**Re: Compark Village South – 2nd Review
F1 AMD 2 – Multifamily – SP21-118**

Compark Village South – F1 AMD 2 – Multifamily – Site Plan - Comments from Plan Sheets

Compark Village South – Subdivision Plan Replat – Fire/Life Safety Comments (Randall Capra)

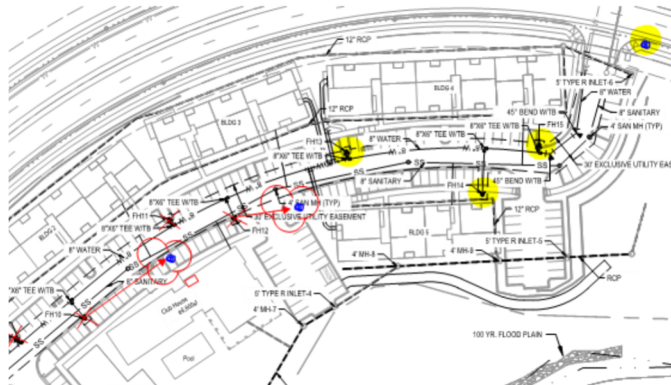
Response: Fire Life Safety signature block has been added.
13. The hydrant distribution has been redlined to accommodate response more effectively; the overall utility drawing shall include the hydrant distribution for all filings and the following criteria. See below for information on hydrant location criteria and on revisions to the hydrant layout (hydrants have been deleted, added, and relocated while shown at entry ways if not currently addressed): ***Partially satisfied; applicant has noted/ acknowledged/addressed with current submittal though a fire hydrant is still required at the eastern intersection of Belford Ave and Deer Track Drive and a hydrant is required at the “T” of Deer Track Lane and Wolf Fox Street (also shown as Bunny Hop Lane... this issue should be addressed with the next submittal, as well) and relocate the fire hydrant in front of building 1. This hydrant is located in the island west of the east end of the building. The island shall be moved over 5 parking spots to align this hydrant between both building 1 and building 2 (as fire hydrants should be within 40 feet of the building to be served). Address these issues when resubmitting: Satisfied; applicant has acknowledged with current submittal***

- Hydrants shall be located no further than 40 feet of the building to be served.
- Hydrants serving buildings with fire suppression systems shall be located in the general area of the riser room.
- Divided roadways require that hydrants be spaced at 250-foot intervals on a stagger (on each side of the road); these hydrants shall be located 500 feet apart on each respective side of the road.
- Hydrants shall be located at the entry into each sub area.
- Hydrants shall be located at the end of most cul-de-sacs.
- Hydrants shall be located at the corners of all streets where possible
- Hydrant spacing shall meet the requirements of the 2018 IFC Chapter 5 and appendix B and C

Response: Thank you. No response necessary.
